Re: VAI Response to Traffic Engineering Peer Review #2
Town Yard Redevelopment
Andover, Massachusetts

Vanasse & Associates, Inc. (VAI) has provided responses to comments that were raised in the April 18, 2024 *Traffic Engineering Peer Review #2* letter prepared by The Engineering Corp (TEC) concerning their review of the March 18, 2024 *VAI Response to Traffic Engineering Peer Review* letter that was been prepared by VAI in support the proposed Town Yard redevelopment to be located in Andover, Massachusetts (hereafter referred to as the “Project”). Listed below are the comments that were identified by TEC in the subject letter that pertain to the March 18, 2024 report and require a response, followed by our response on behalf of the Project proponent.

Not To Scale **Figure A1**

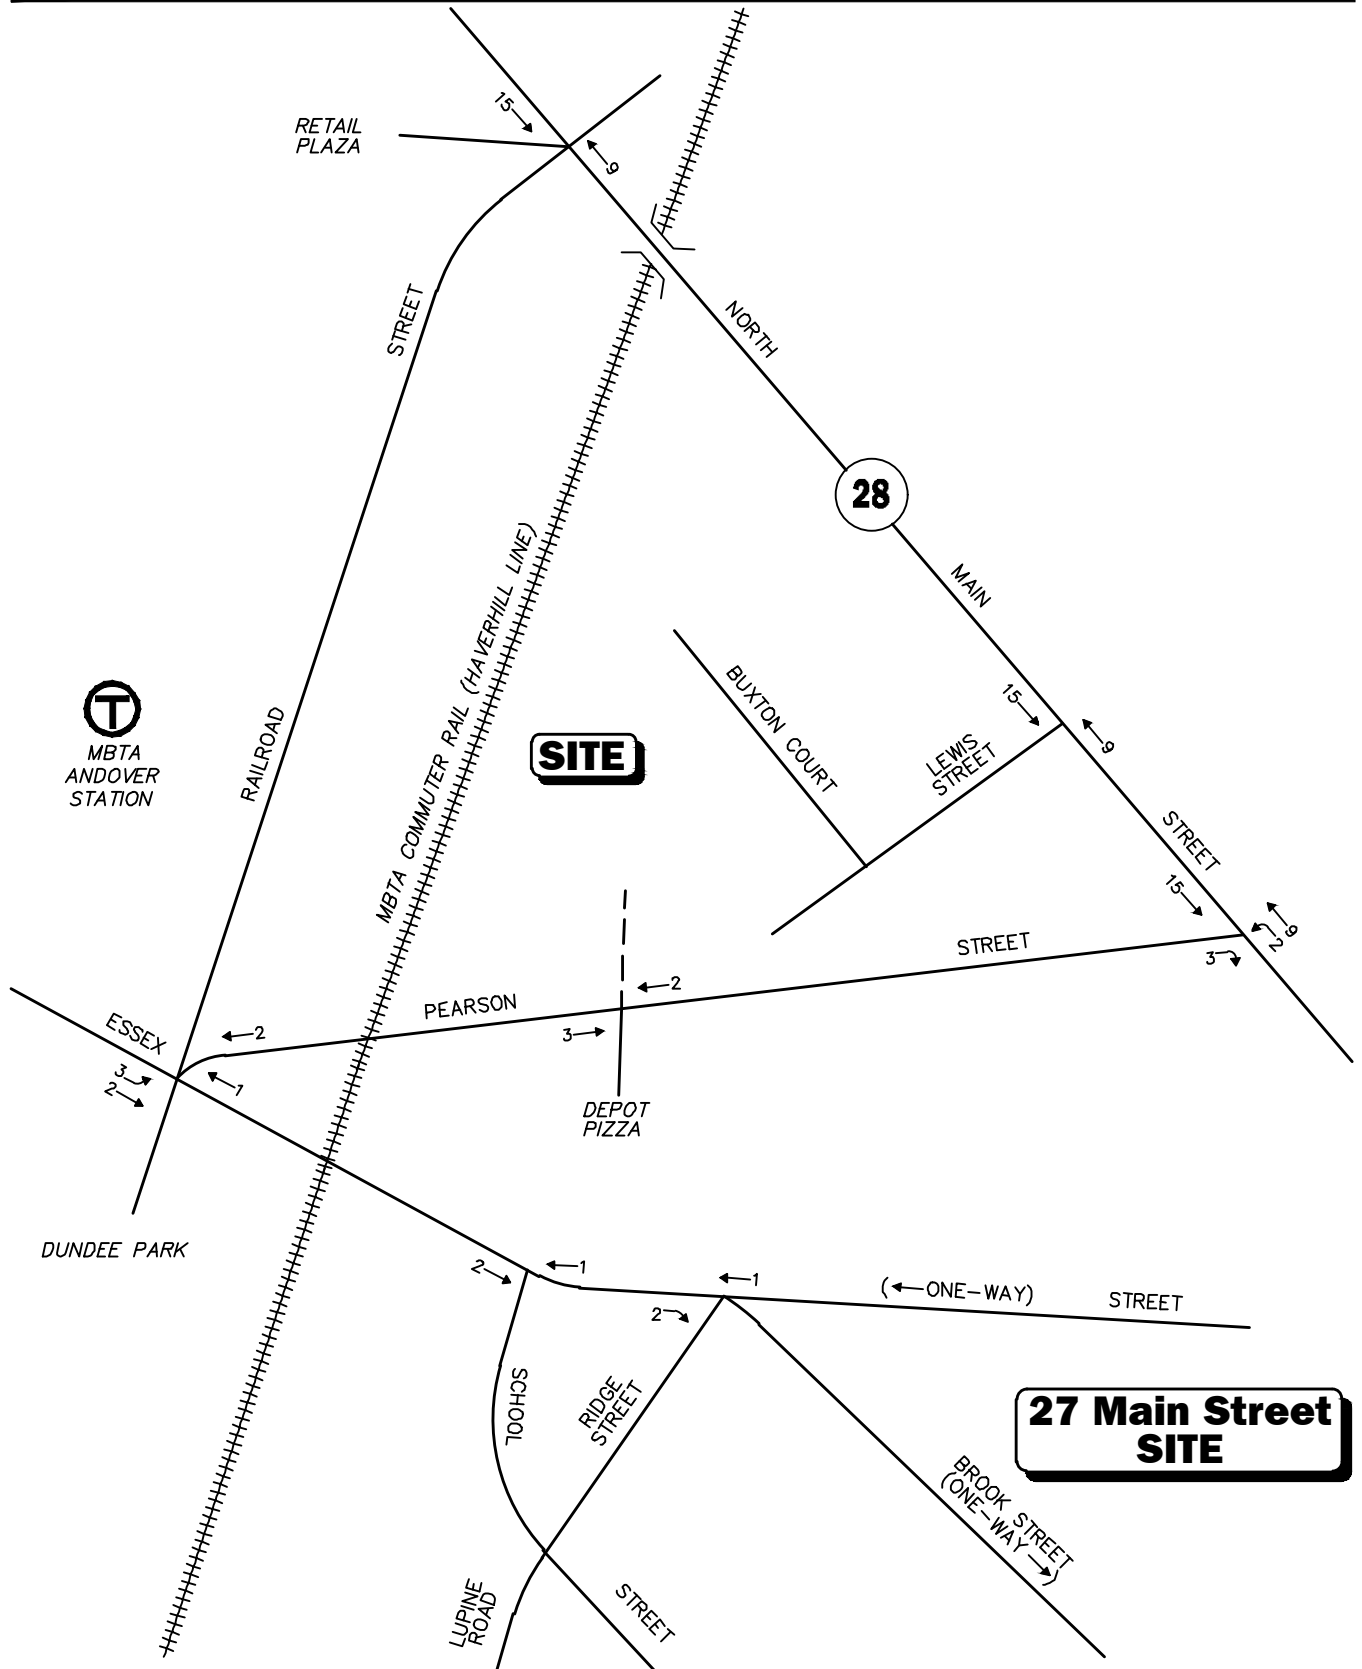
Comment 9: *To obtain future year volumes (2030), the September counts were adjusted at a rate of 1% per year compounded, based on area growth between 2009 and 2019. This growth rate accounts for background traffic as well as for a specific development by others (#305 North Main Redevelopment). TEC finds this acceptable. Another project described is located at the Draper Block – #27 Main Street. The TIA states that based on a special permit for this project site-generated trips were included in the Town Yard Redevelopment; however, the trip generation for Draper Block, which would be applied to the 2030 No-Build volumes, has not been provided in the TIA, and therefore, cannot be confirmed.*

TEC Response: *The Applicant has provided a marked-up version of the trip generation. Is there a clean version directly from the project's TIA?*

VAI Response: The 27 Main Street project (Draper Block project) site-generated trips are shown in the Appendix to this letter as Figure A1 and Figure A2.

VAI Response: The Town did not have a traffic study for the Draper Block project, and the only documentation available was a copy of the Special Permit. Trip generation was therefore estimated using ITE data and the information in the Special Permit, and trips were assigned using engineering judgment. The trip generation and figures are included in the Appendix to this letter.

Figure SD-1A

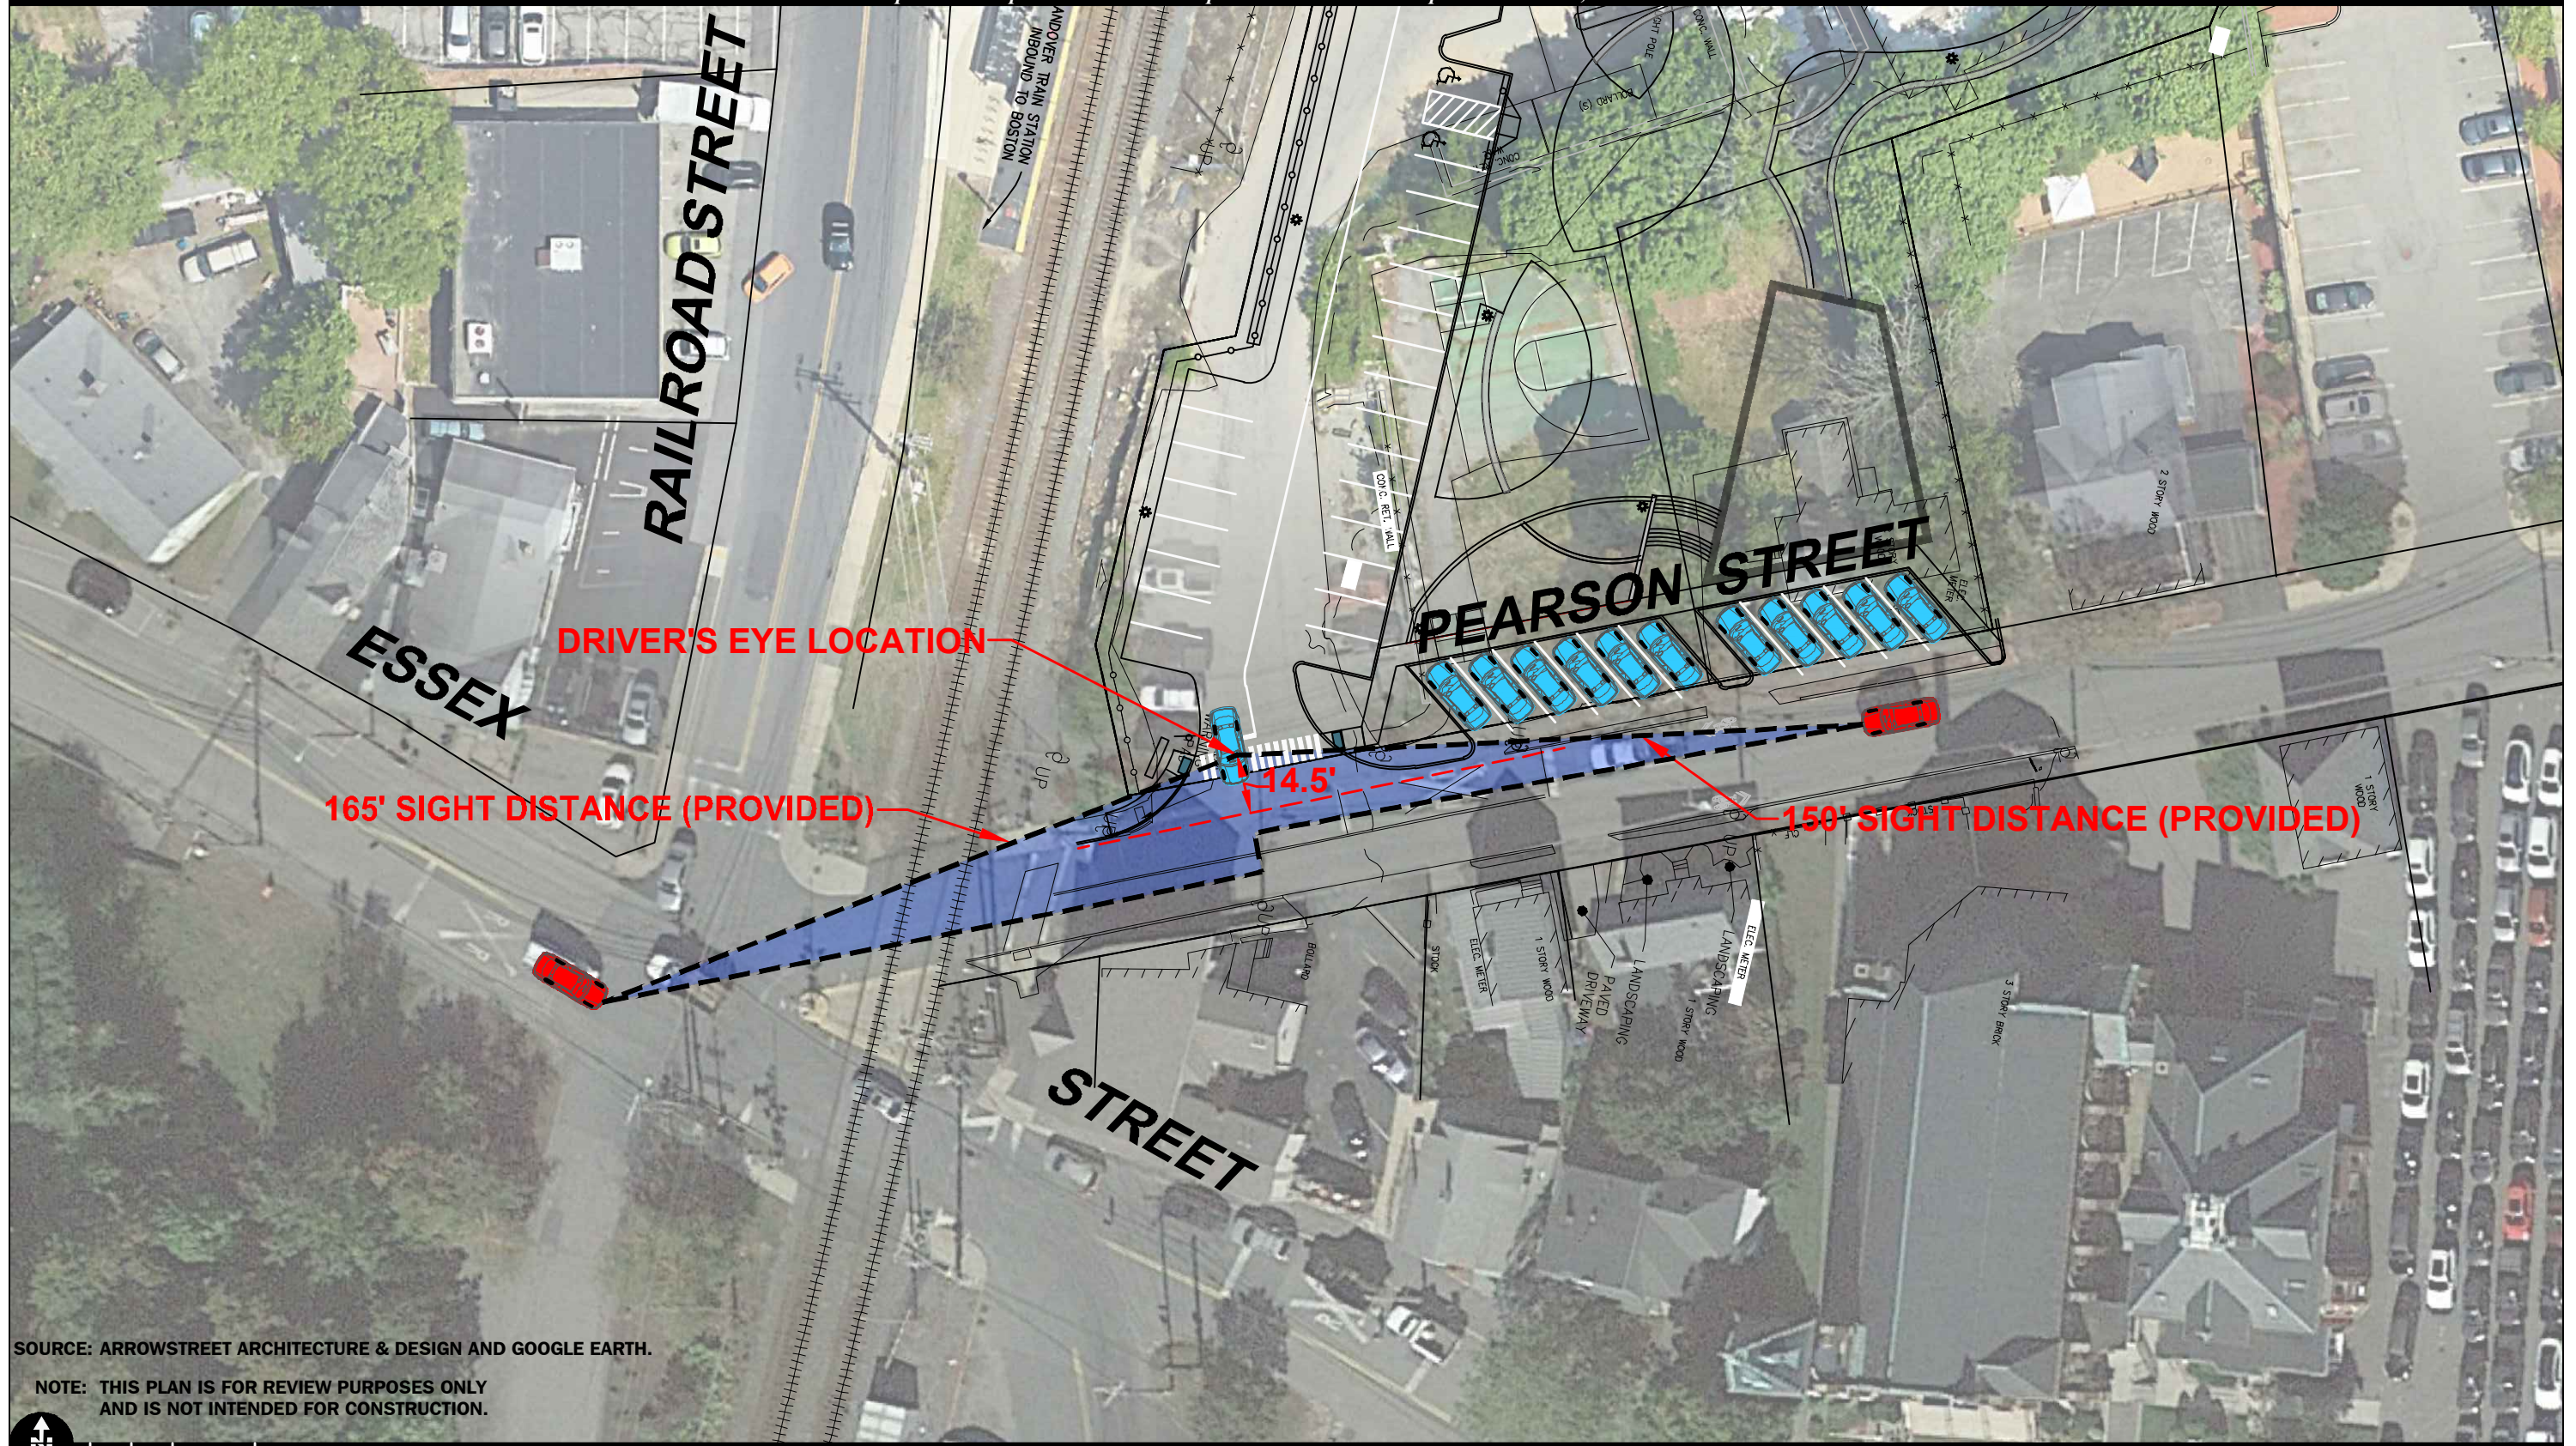
Comment 13: *The Applicant has provided stopping sight distance (SSD) and intersection sight distance (ISD) measurements for the Site Driveway along Pearson Street. The results are shown in Table 8 of the TIA and have been compared to recommended values obtained from A Policy on Geometric Design of Highways and Streets, 7th Edition, American Association of State Highway and Transportation Officials (AASHTO), 2018. The measured distances have been shown in the TIA to exceed these values, except for the ISD for vehicles looking west while exiting the site (111 feet). However, Table 8 contains notes stating that three of the four measured distances have been determined if parked cars to the east were removed and if a hedge to the west were cut. The fourth measured distance of 241 feet (SSD approaching from the west) is questionable since Pearson Street is roughly 100 feet from its intersection with Essex Street to the site driveway. A distance of 241 feet could only be attained by measuring further west along Essex Street, which places the limit about 150 feet from the railroad tracks. At this point, the sight distance is further affected by a concrete retaining wall in the parking area of Ann's Cleaners at #2 Railroad Street, as well as a railroad signal gate and utility poles on Pearson Street near the proposed site driveway. The Applicant should provide a graphical depiction, preferably in the form of a sight triangle sheet in the site plans, of the sight lines for this driveway. Sight lines to the east along Pearson Street should not cross over the head-in parking stalls proposed along the northerly side of the roadway.*

TEC Response: *TEC acknowledges the sight line graphic SD-1 provided; however, the Applicant has not addressed sight line related items towards the west or the tracks in the above comment. TEC acknowledges that these sight lines may be moot based on the Mass Works project; however, there is no guarantee that the project will be completed even if funded.*

VAI Response: See updated Figures SD-1A and SD-1B in the Appendix to this letter depicting sight distances east and west of the driveway assuming Pearson Street remains continuous to Essex Street.
